BURLINGTON DEVELOPMENT REVIEW BOARD Tuesday May 19 2015 PUBLIC HEARING NOTICE

BURLINGTON DEVELOPMENT REVIEW BOARD Tuesday, May 19, 5:00 p.m. Contois Auditorium, City Hall, 149 Church Street, Burlington, VT AGENDA

To: Development Review Board
From: Mary O'Neil, AICP, Senior Planner
Date: May 19, 2015
RE: 54 Muirfield Drive, ZP15-1039CA/HO

JOB MEMO: 451 & 465 Appletree Point Road
RE: DRB & DAB Application Submittal
DATE: March 26, 2015
TO: Scott Gustin, Burlington Planning and Zoning
FROM: Brad Rabinowitz

BUILDING SECTIONS- 451

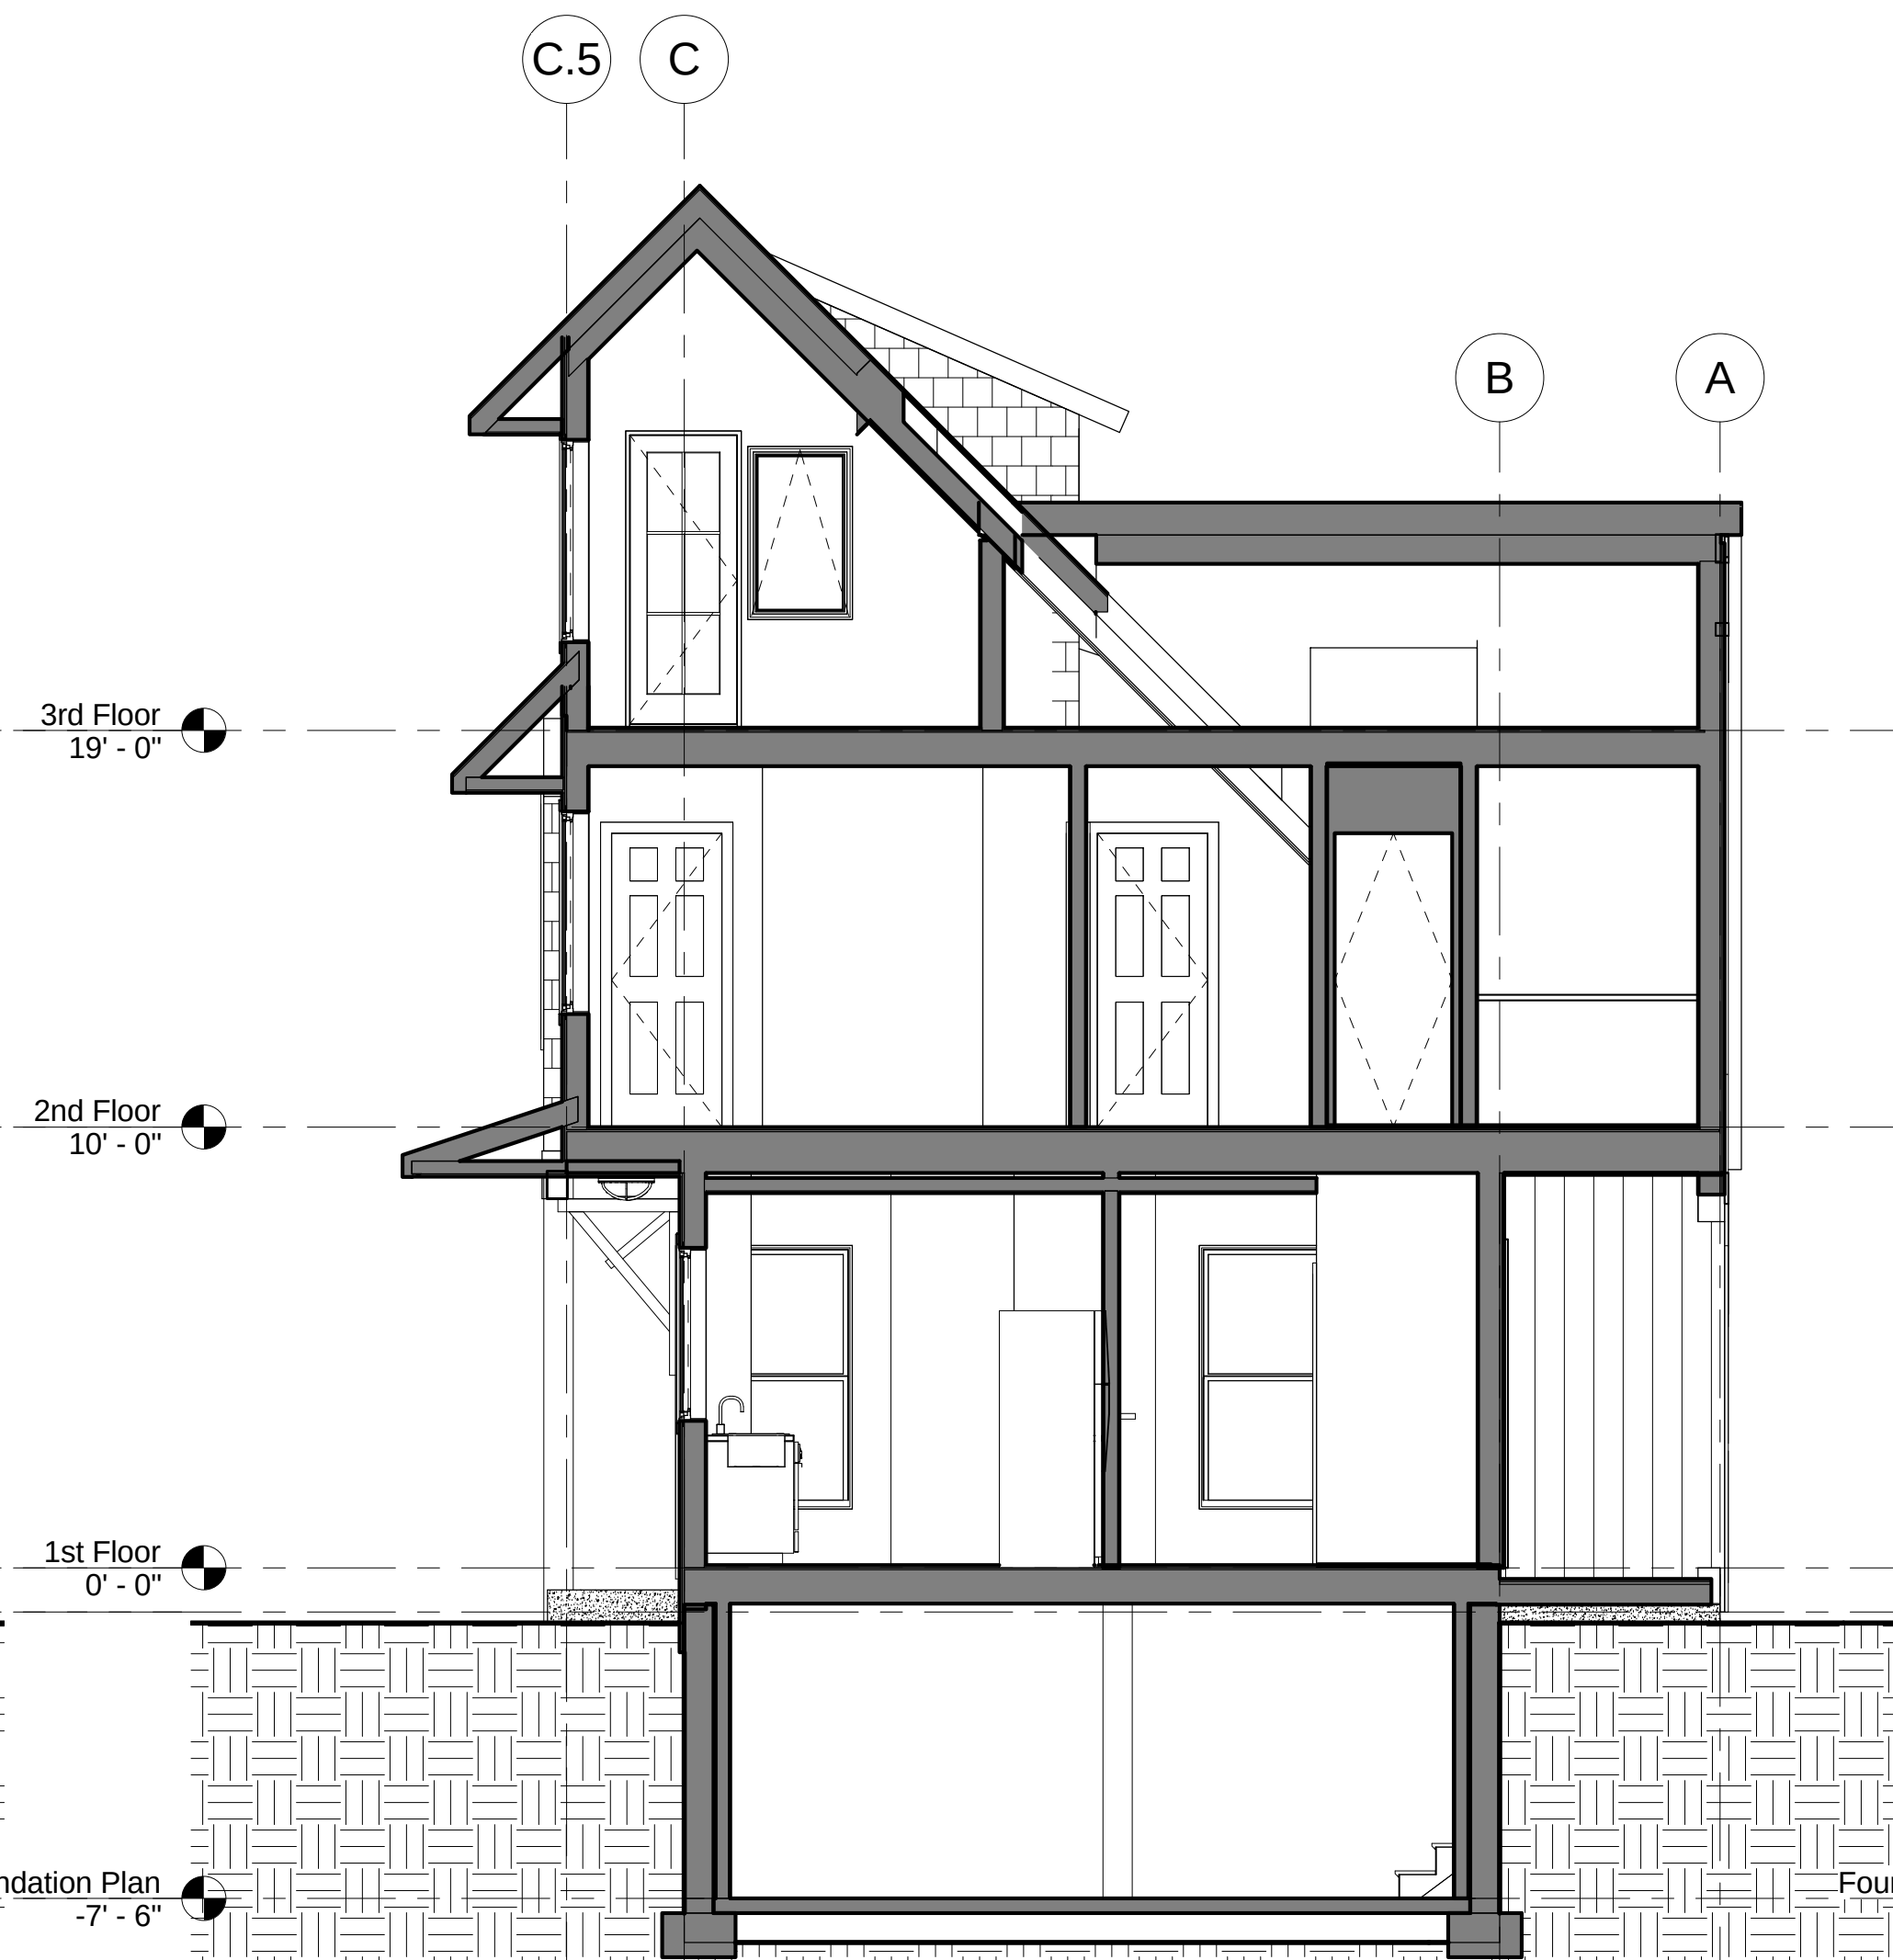
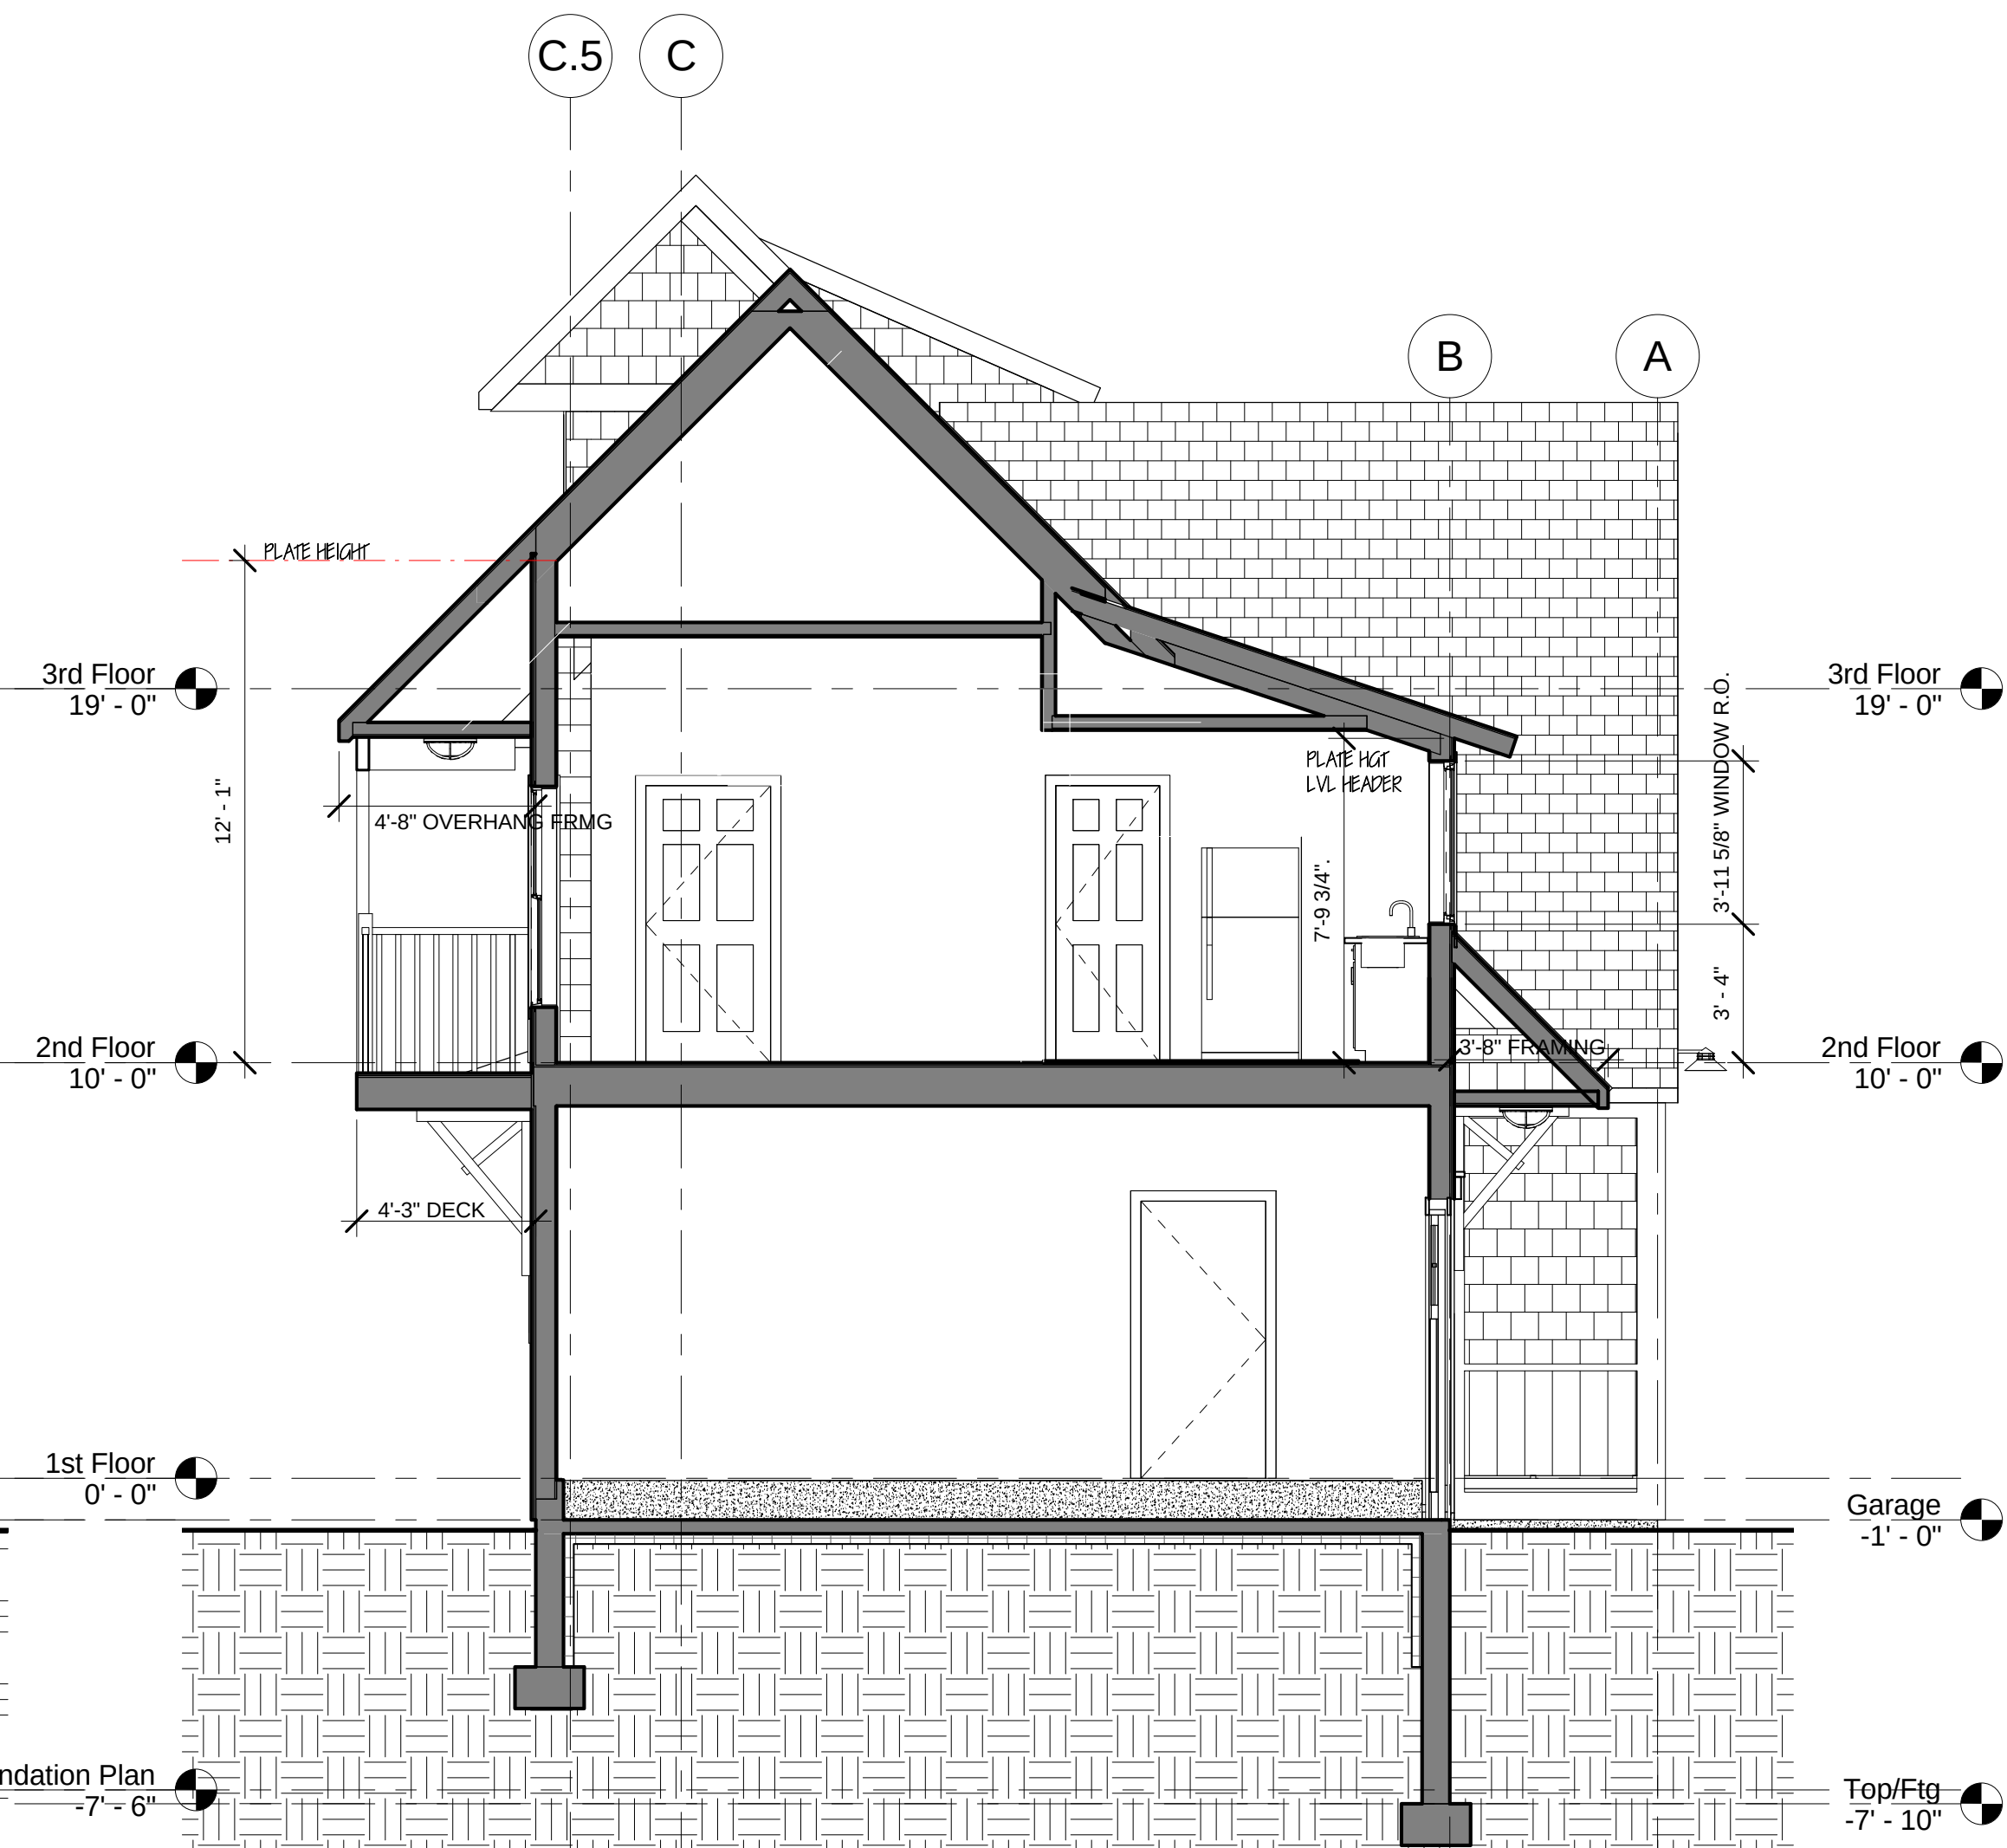
The multiple roof planes and dormers make a clear height measurement to the midpoint of the roof rise elusive. It appears to be about 20.' The very peak of the structure is 33', below the 35' height limit. **(Affirmative finding)**
